Memorandum

Subject: **SITE PLAN REVIEW**—1900 N Croatan Highway in the Commercial Zone — Proposed Convenience Store and Gas Station

**RE: *2nd Site Plan Submittal for Wawa Croatan Highway
1900 North Croatan Highway
Kimley-Horn #116543032***

SHEET NUMBER
CL101

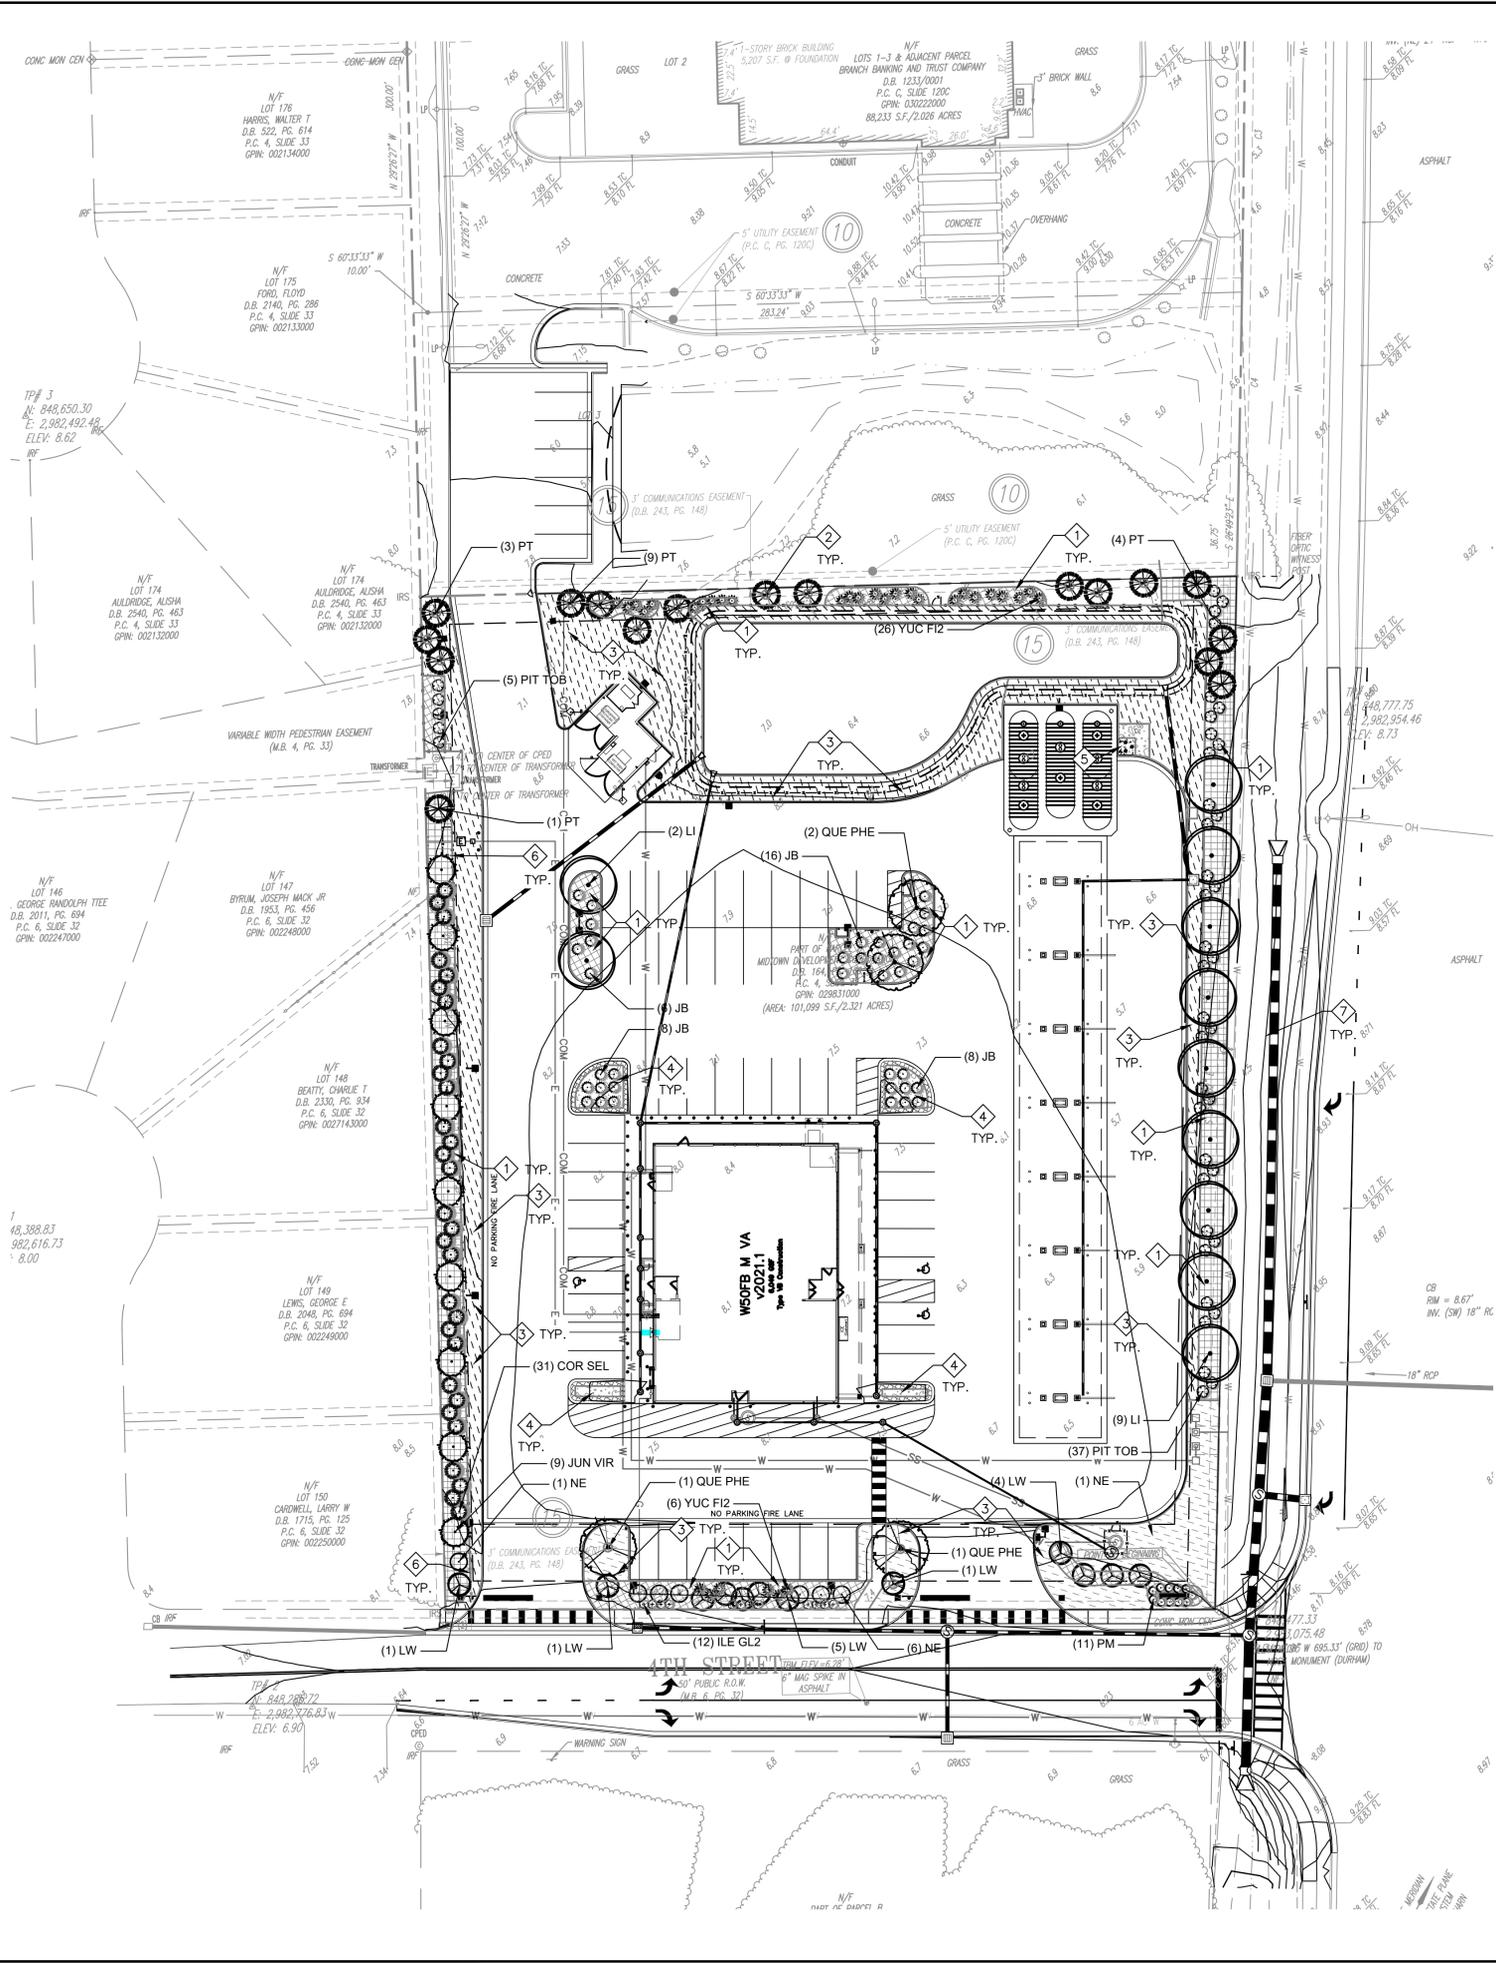
- a. Parking Lot Interior Green Space: Trees required at 1 per 10 Parking Spaces

- b. List number of shrubs provided for Parking Lot Interior Green Space.

- The number of trees provided for the front perimeter yard have been added to the landscape calculations.
 - c. West Property Line shall have side yard landscaping requirements. A fence or dense vegetative screen shall be provided. If fence is utilized as a buffer, ornamental landscaping shall be provided. In all cases where a fence is constructed, the required landscaped area be located between the fence and the property line.

- The west property line has had a fence added with ornamental landscaping between the property line and the fence.
